This Service Information bulletin supersedes SI M71 01 15 dated **January 2015**.

Recall Campaign 15V-034: Replace Vehicle Identification Number (VIN) Label and Tire Label on Left B-Pillar

F56 (Cooper Hardtop 2-door)

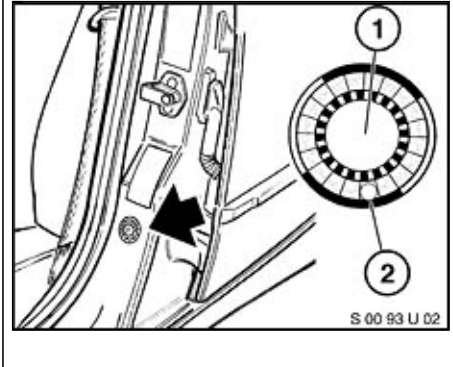
The maximum vehicle load (on the tire label) and gross vehicle weight rating (GVWR, on the VIN label) have been increased.

Note: The photo shows the location of the changed specifications, and does not indicate the correct values.

Compare the new label versus the old label to verify that the VINs match and the GVWR is different (has increased) **before the old label is removed!** Remove the tire pressure label (upper arrow) and the VIN label (lower arrow) from the driver's B-pillar.

- Carefully use a heat gun to soften the adhesive backing on each label.
- Remove the label with a plastic wedge.

Remove all adhesive residue from the B-pillar with an appropriate cleaner (brake cleaner, rubbing alcohol).
